**HISTORIC LANDMARK COMMISSION
JANUARY 27, 2014
CERTIFICATE OF APPROPRIATENESS
LHD-2013-0022
808 Blanco Street
Castle Hill Local Historic District**

Add a 1/2 story addition to a contributing house.

Thomson Residence 888 Blanco St. Austin, Texas 78703	
	DATE	01.02.2014	
	ISSUED FOR PERMITTING		
		DRAWN BY: CAG, DYN	
SHEET TITLE			
ELEVATIONS			
SHEET			
A2.2

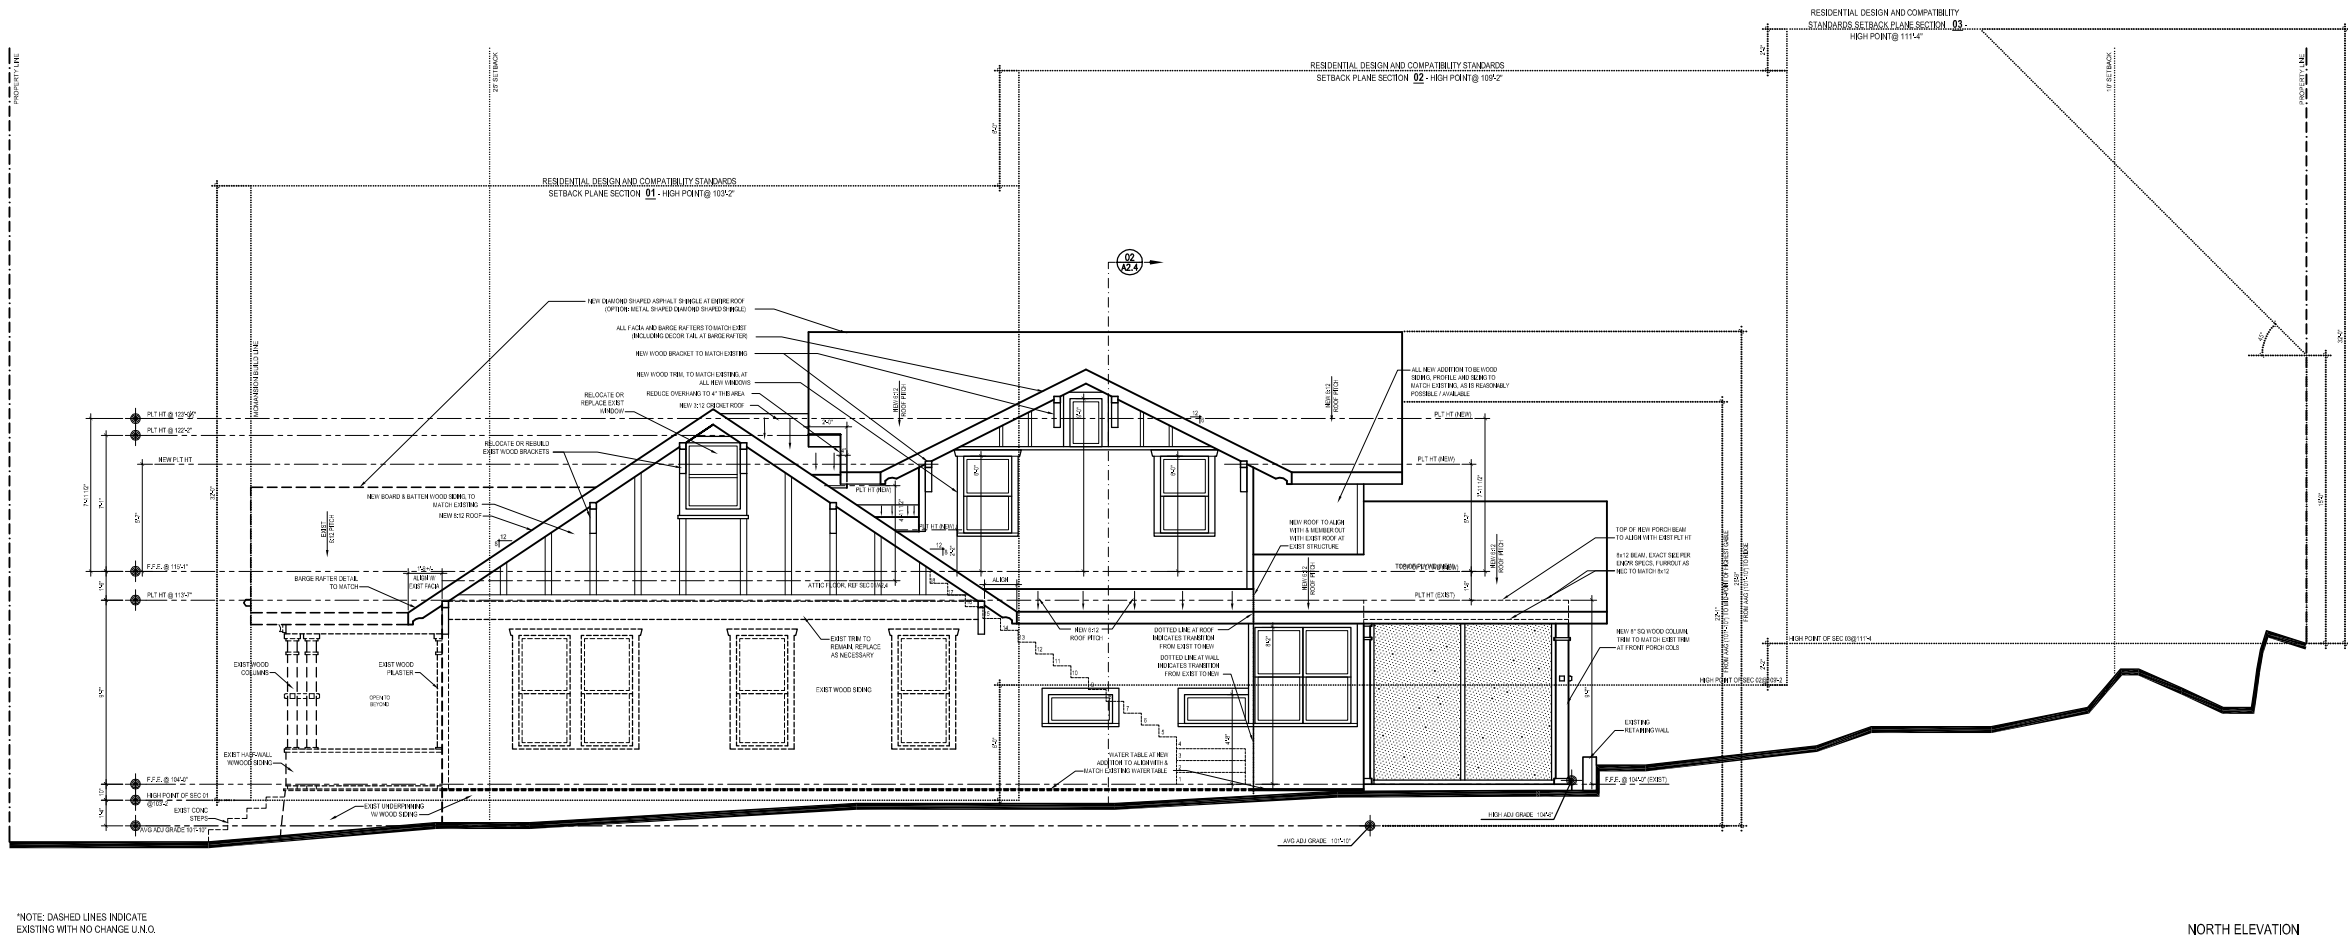
The applicant proposes to add a ½ story addition behind the existing ridge line of the house, and a rear screened porch. The addition will have a front facing gable with side gabled dormers. The gable ends will have a trim design similar to that on the existing house but will not have decorative brackets. The walls of the addition will have siding similar to that on the existing house.

Simply the bracket design on the addition. Removing the second front door is acceptable.

Approve the Certificate of Appropriateness eliminating the decorative brackets on the addition and removing the non-original door.
